(10) **Patent No.:** **US D593,823 S**
(45) **Date of Patent:** **** Jun. 9, 2009**

(54) **MULTIPLE FUNCTION SHANK FOR A NUT DRIVER**

UNITED STATES PATENT AND TRADEMARK OFFICE
CERTIFICATE OF CORRECTION

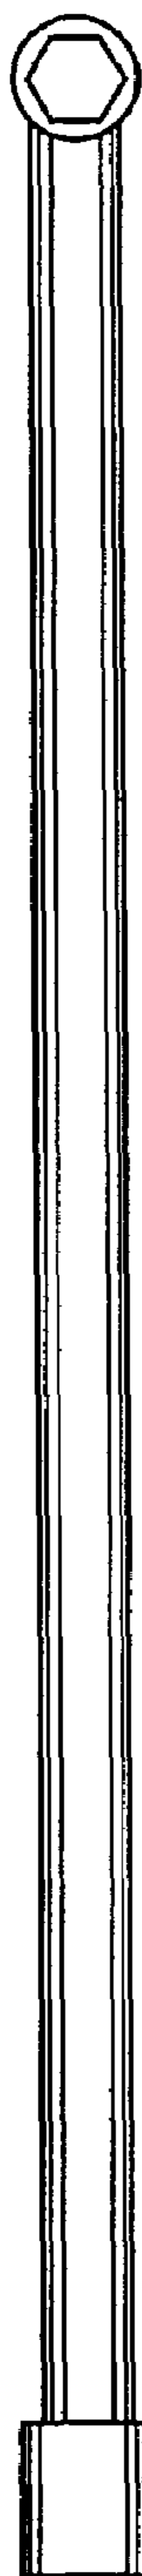
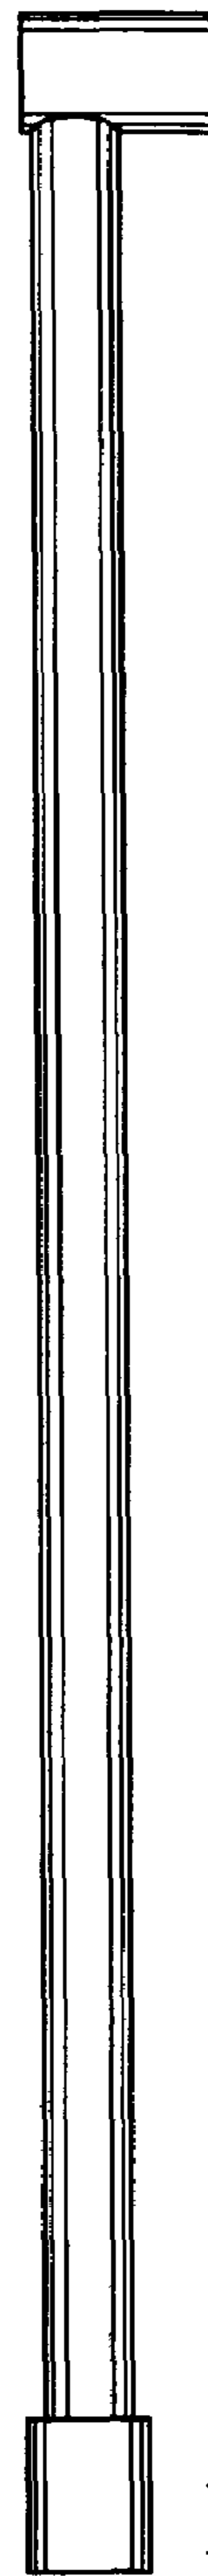
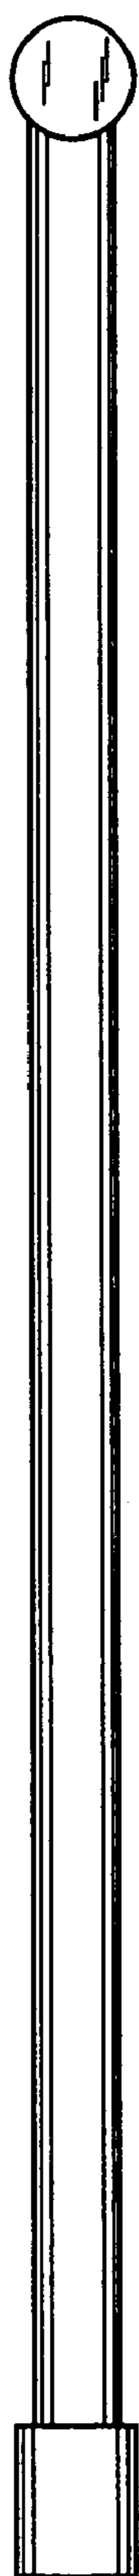
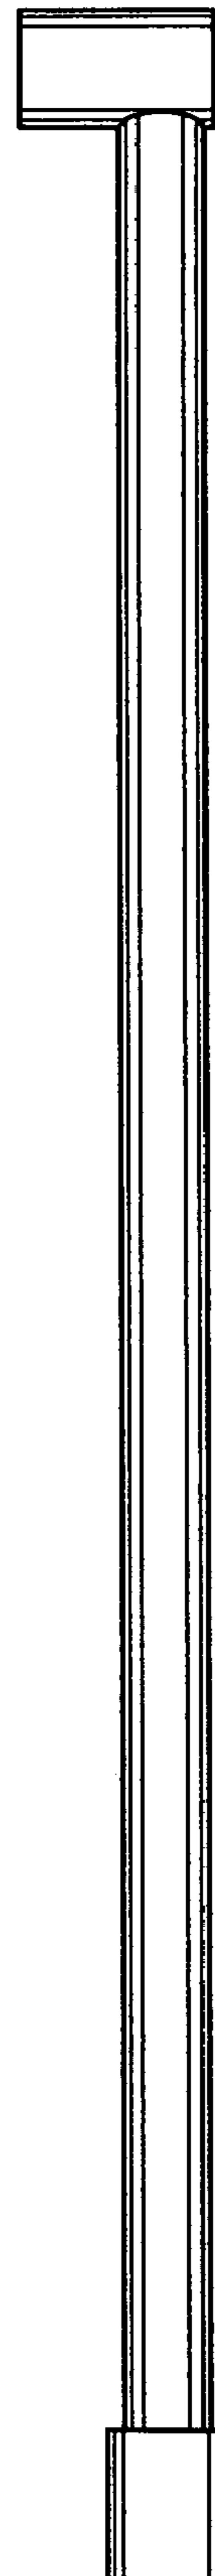
1. Specifically, on the front page of the patent, under the heading, DESCRIPTION, the word plan has been erroneously omitted from the description for Fig. 2. The sentence should read; Fig. 2 is a top plan view thereof;
2. Specifically, on page 2 of the drawing sheets, Fig. 2, Fig. 3, Fig. 4, and Fig. 5 have all been shrunk down . These Figs. are now not proportionately the same as all of the other Figs in the patent.

Sheet 6 of 6

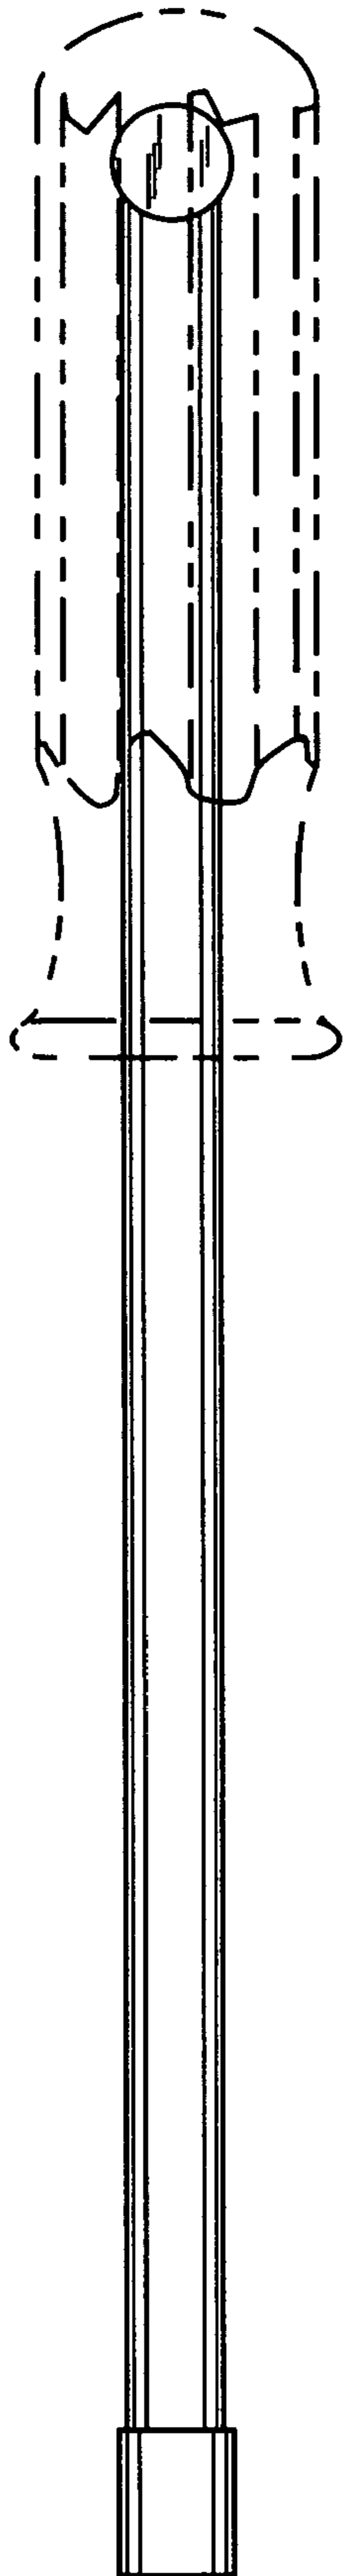
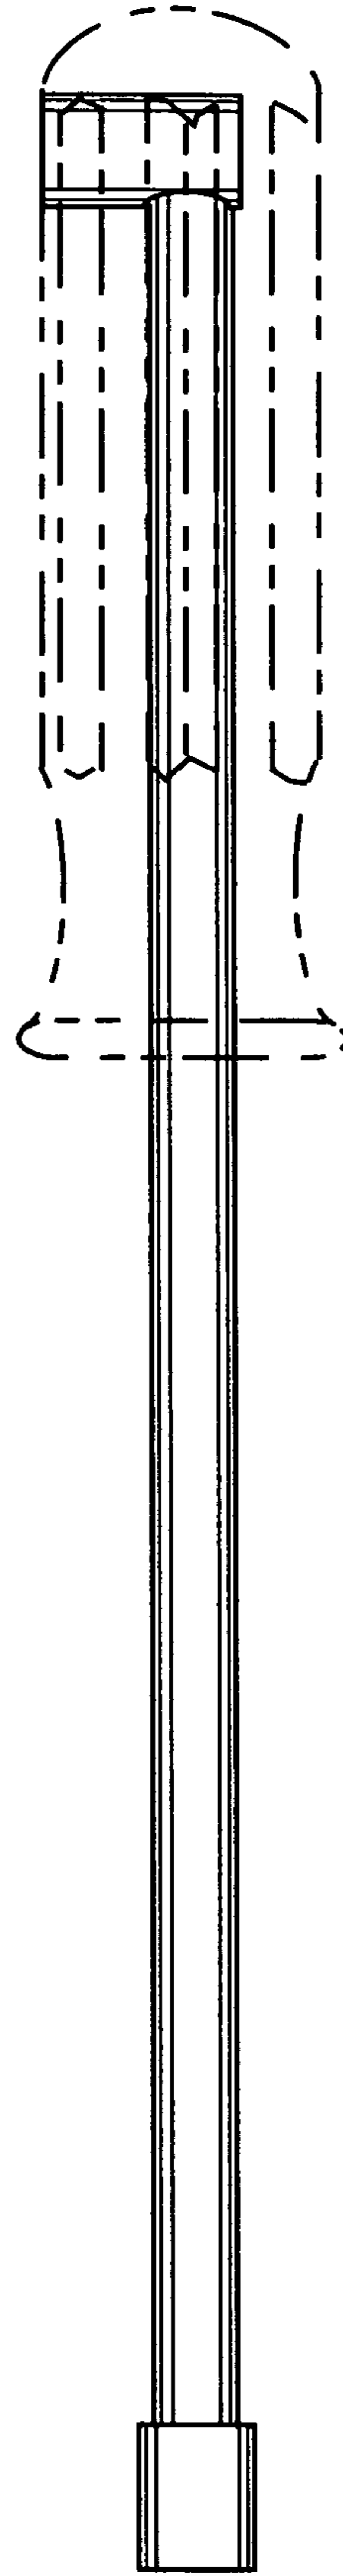
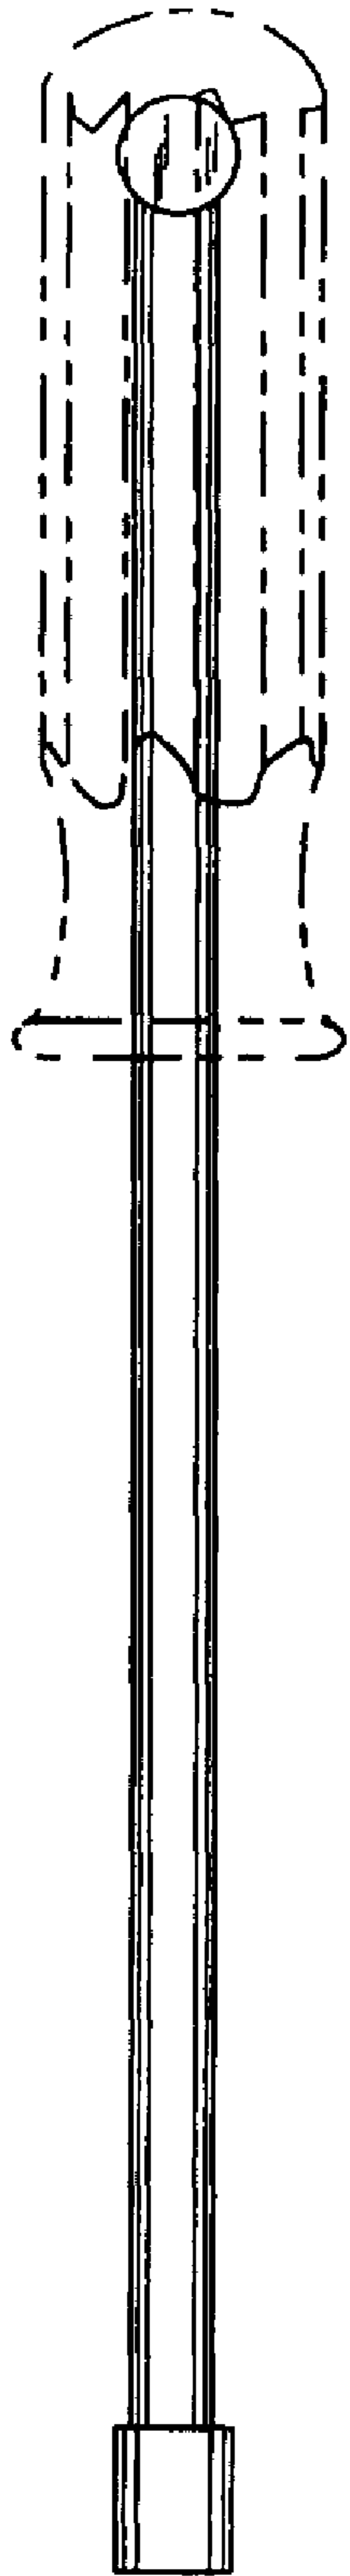
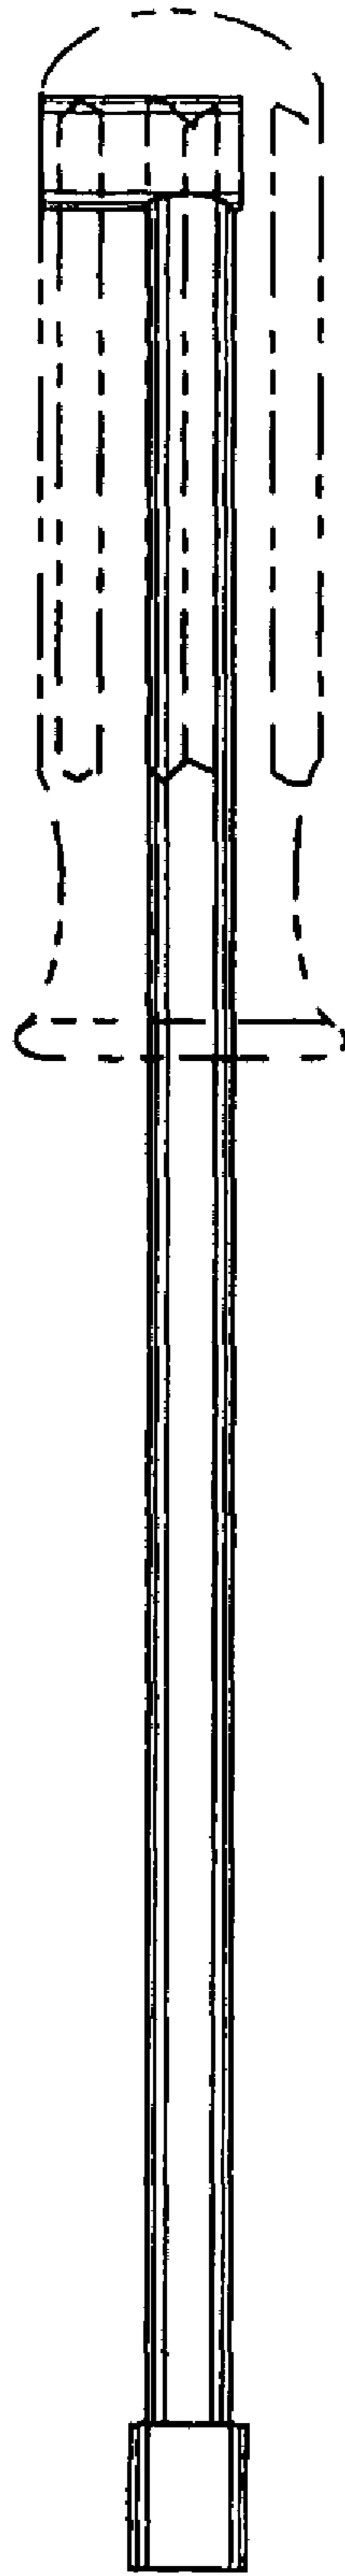
The drawing sheet, consisting of Figs. 11 and 12, should be deleted to be replaced with the drawing sheet, consisting of Figs. 11 and 12, as shown on the attached pages.
